Board of Appeals

STAFF REPORT

Project Title:	Appeal of 200 Sydney Drive Variance and Tree Permit
County File(s):	#VR14-1021
Applicant/Owner:	Ahmad Rassai
Zoning/General Plan:	Single Family Residential (R-20); Single-Family Residential, Low-Density (SL) / Open Space (OS)
Site Address/Location:	200 Sydney Drive (APN: 188-412-014)
California Environmental Quality Act (CEQA) Status:	Exempt, Section 15303(a) - New Construction, or Conversion of Small Structures
Project Planner:	Sharon Gong, (925) 674-7802
Staff Recommendation:	Approve (See Section II for Full Recommendation)

FRONT AND
SIDE
ELEVATIONS

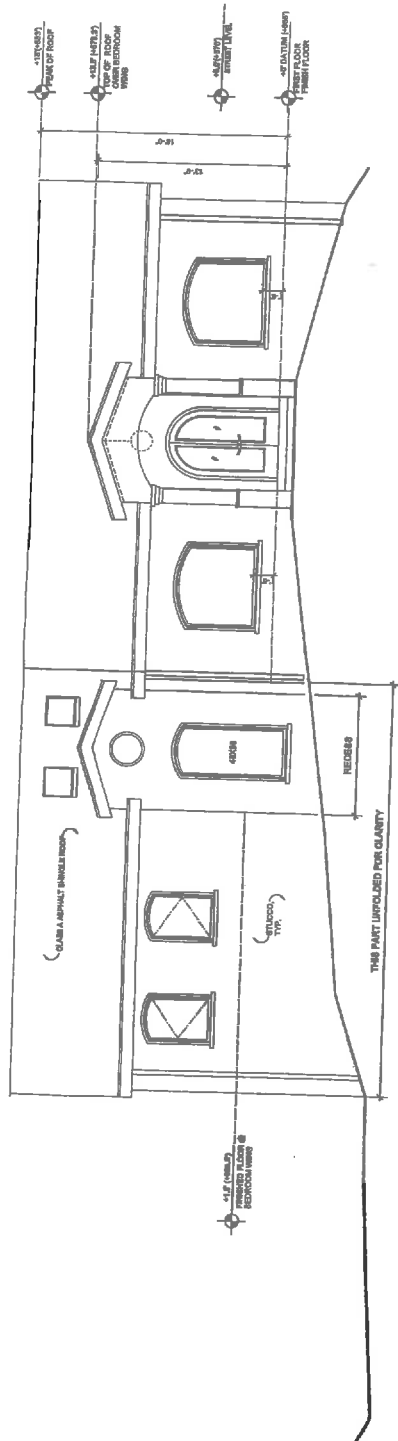
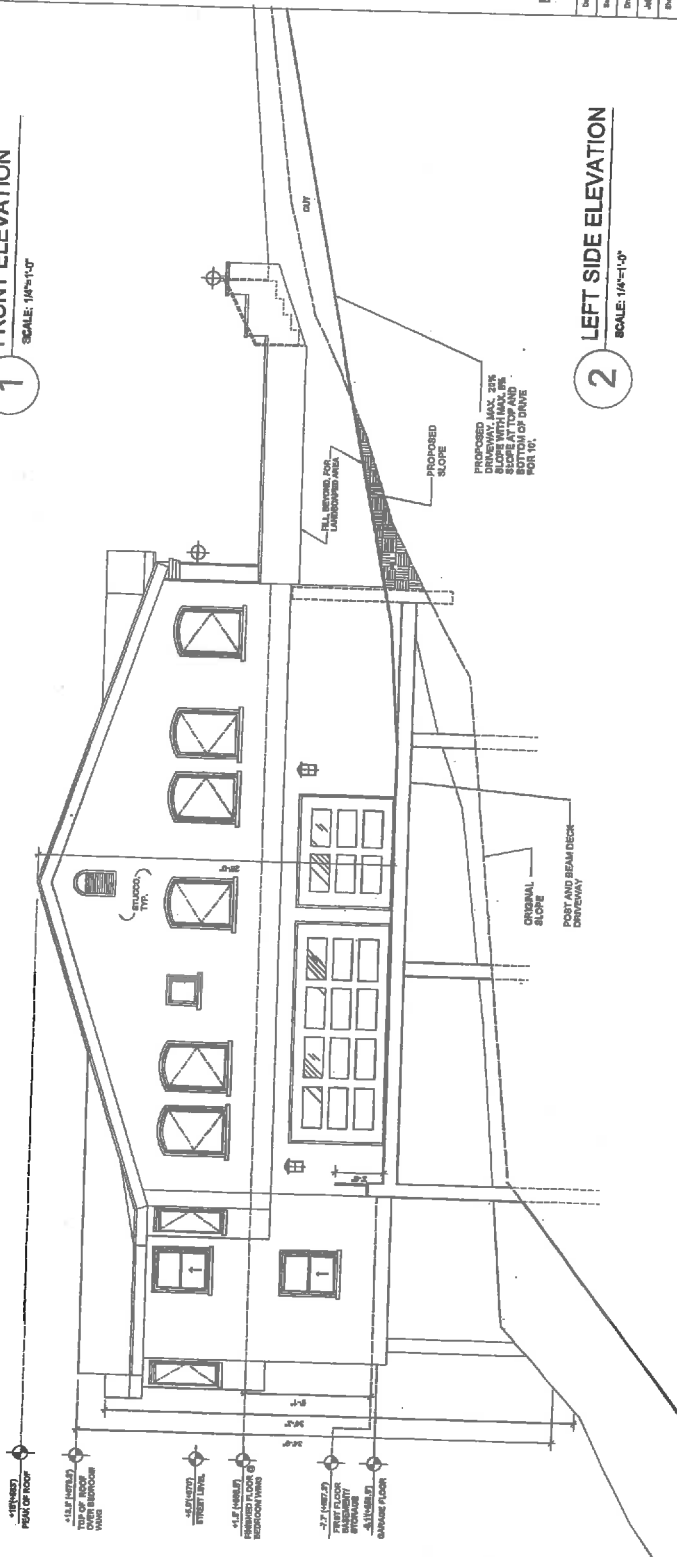
- C. ***Summary of Appeal Point #3: The topo map provided is from 1985, and is not stamped and signed by the surveyor. The grades shown on the 1985 topo map do not match the cross section and elevations views - specifically the grades shown on Sheet A4.0. Insufficient cross sections have been provided. Incorrect and flawed information on the drawings make it difficult to evaluate critical height issues, which are related to the requested front entry variance.***

- The building would be even MORE out of compliance related to the height.
 - The requested front variance will also be affected.
- Height of Building and Planning Code Violations.
Plan Sheet No. A-4 shows an existing grade which does not match the grades on the 1985 topo map. This sheet also seems to show another proposed grade about 3-feet higher than the existing grade. Planning regulations require the maximum height to be measured to the existing grade and not the new proposed grade. The plans show the height of the building as 34-feet 9-inches to the newly proposed grade which would clearly violate the maximum height allowed by the planning regulations. The ZA should recognize that this is a fatal flaw with this project. The height of the building is a critical item which is related to the requested front entry variance.

- The grades shown on the 1985 Topo map do not match with the cross section and elevation views. This requires careful and in depth scrutiny.
- Insufficient cross section views have been provided. As a result, it is impossible to ascertain the true number of stories and the true height of the proposed development.
- As further explained below, these two issues lead to critical concerns related to the number of stories, the building height, and the driveway slopes and elevations. All of which must be represented accurately on the plans in order to evaluate the project. Once the project is built correcting it will be painful and expensive.

Staff reviewed and cross-checked the grades and elevations on Sheet A4.0 of the drawings, and found that there were mistakes in the representation of the grade at the west side of the house, at the master bedroom. When the correct grade was determined, it was found that the house did exceed the 35-foot height limit at the master bedroom. After Staff discussed this with the applicant, he recognized the mistake and decided to slope the roof at the master bedroom to bring the height into compliance with the 35-foot limit. Revised and corrected drawings prepared by a licensed engineer were submitted on December 29, 2014. Additional sections showing the heights at the master bedroom and second tallest part of the house were also submitted as evidence of compliance with height limitations.
